GOVERNMENT OF THE DISTRICT OF COLUMBIA
DISTRICT DEPARTMENT OF TRANSPORTATION

MEMORANDUM

SUBJECT: **Supplemental Report/** Z.C. No. 07-21 – Consolidated Planned Unit Development (PUD) Located at 22nd and M Street, NW

RE: I Hotel – 2201 M Street
Washington, D.C.

Exhibit A-1
Traffic Flow Diagram for Public Alley

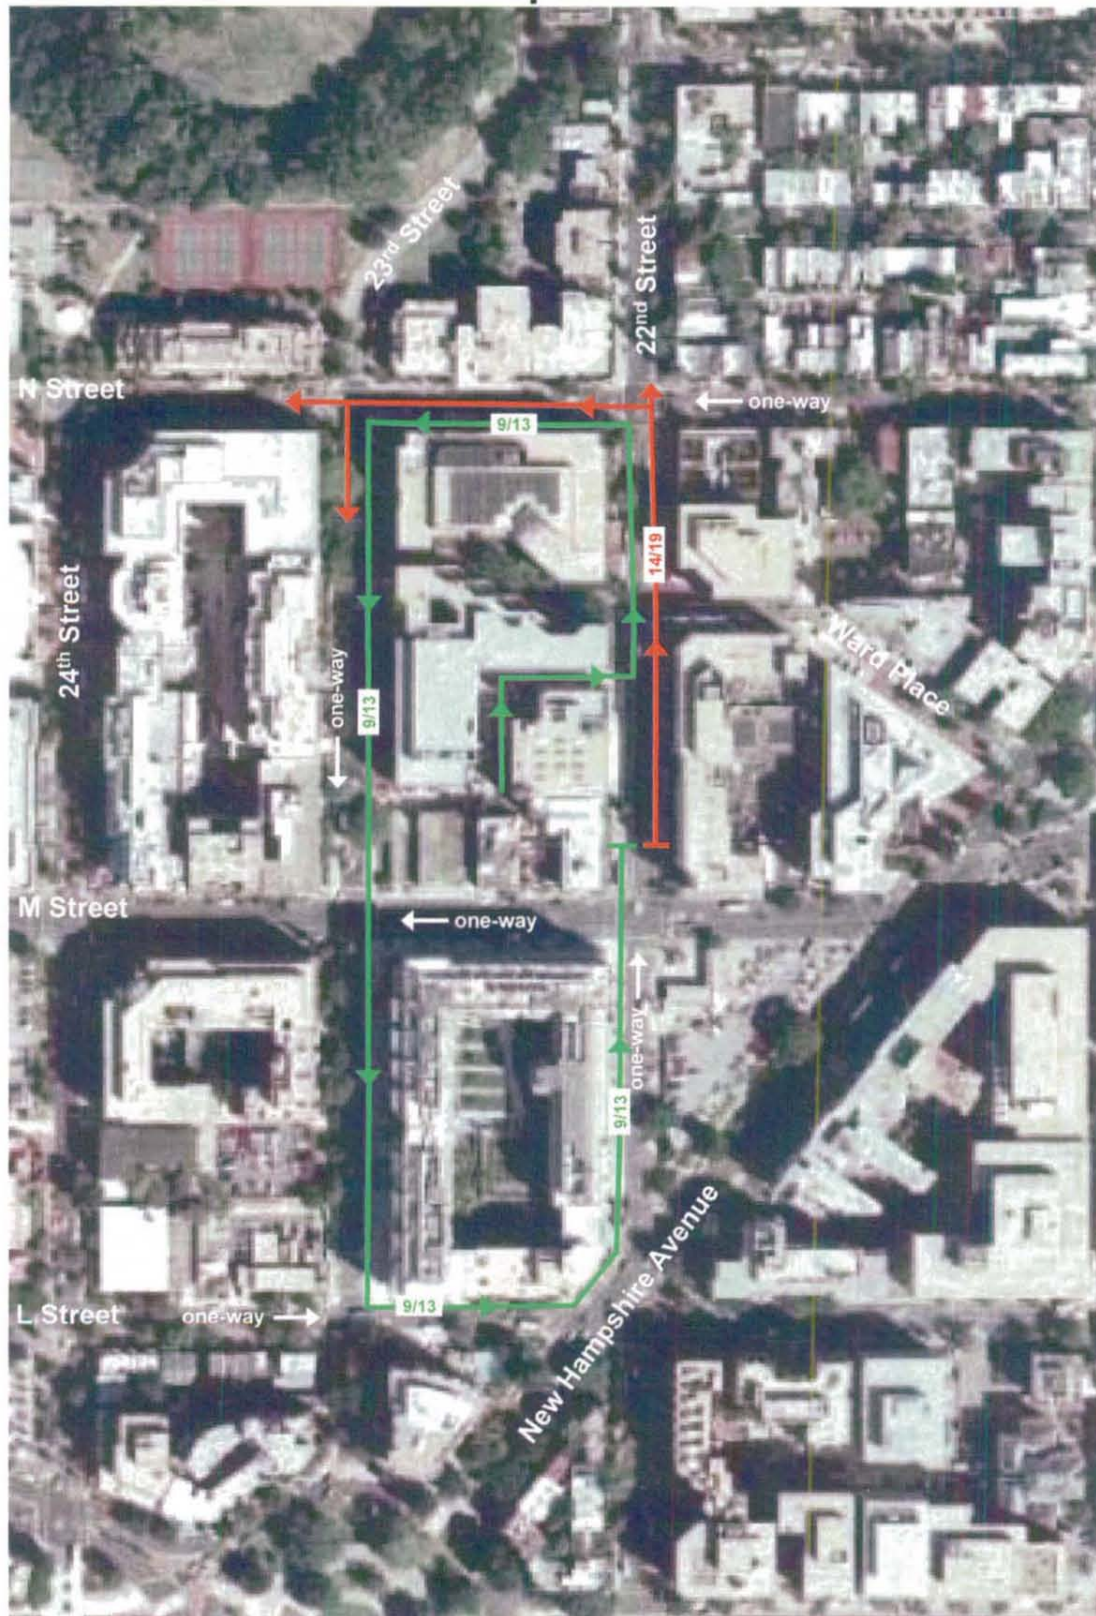
The public alley located at the rear of the project does not provide enough maneuvering space for vehicles to accommodate both the required loading facilities and the parking

garage entrance. (Attachment - B) Furthermore the parking garage incorporates an elevator system, instead of the typical ramp, to carry cars from grade to the parking garage levels below by using valets to park and retrieve cars, with patrons waiting at the garage entrance. The project abuts two one-way streets with M Street traffic heading westbound and 22nd Street, NW traffic heading north, requiring vehicles leaving the garage to exit the alley network onto 22nd Street, NW north of the project site then make a two block circuitous route using 23rd Street and L Street, NW to return to the hotel frontage. (Attachment - C)

The impracticality of providing both the loading dock access and the garage access from the alley is evident by viewing Exhibit A-1 in Attachment A. As shown on Exhibit A-1, the configuration of the site is such that it is bordered by streets on two sides and existing buildings on the other two sides. As such, there is insufficient alley frontage to provide both garage access and loading dock access from the alley.

Based on the site constraints in the public alley, the traffic patterns of the surrounding road network and the operations of the parking garage, DDOT agrees with the applicant that placing the parking garage in the public alley is impractical and does not object to the applicant providing a driveway entrance on 22nd Street, NW. To address safety concerns the applicant modified the design of the proposed parking garage by creating a 19 ft. setback at the garage entrance that would provide enough room to store up to two vehicles within the driveway without impeding pedestrians. The proposed lay-by on 22nd Street, NW has been reduced in width to provide a wider sidewalk with curb-trees that were absent on the original submission. (Attachment - D)

Exhibit B-1
Traffic Circulation Diagram

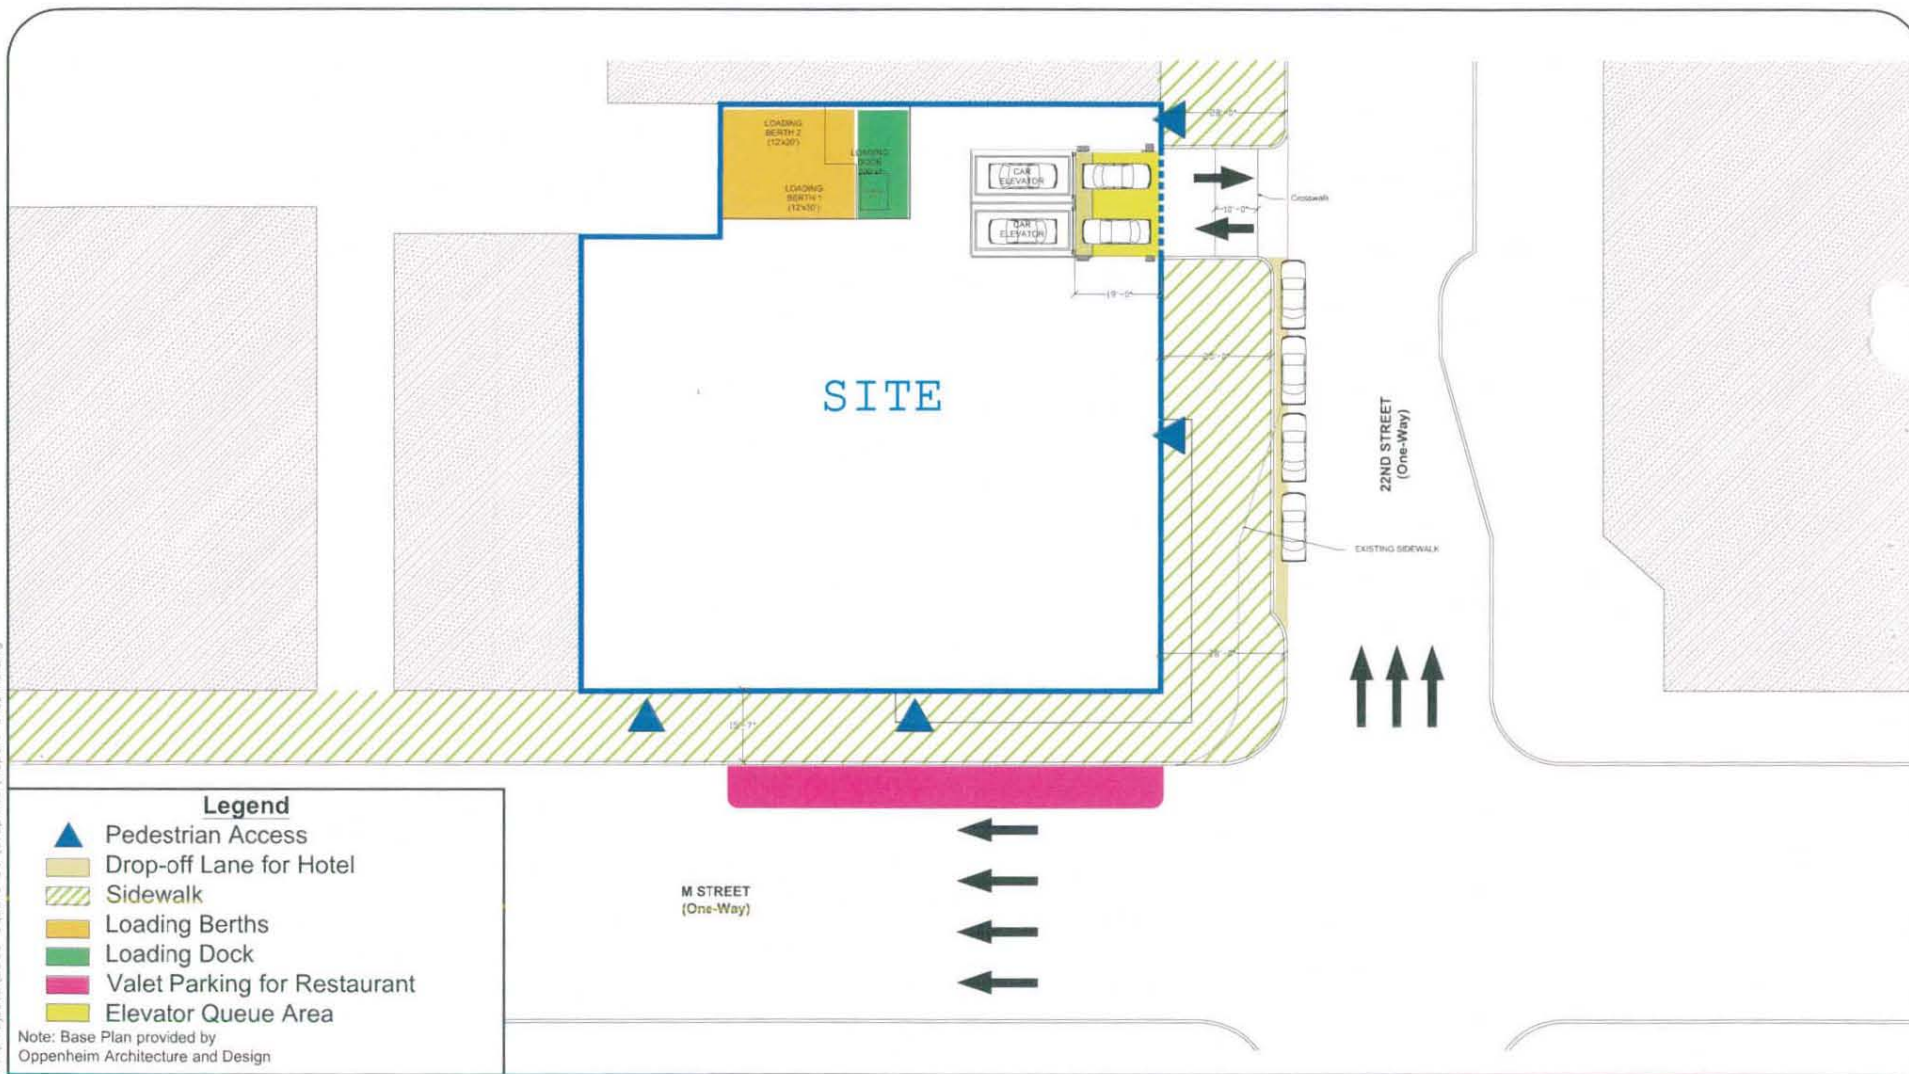
Based on DDOT's feedback at the March 5th meeting, the proposed lay-by lane has been modified as shown on Exhibit B-1 in Attachment B.

The proposed curb-line would be aligned parallel to the 22nd Street travel lanes and offset from the existing travel lane by three feet. The lay-by lane would be similar to the existing lay-by lane on Connecticut Avenue in front of the Mayflower hotel.
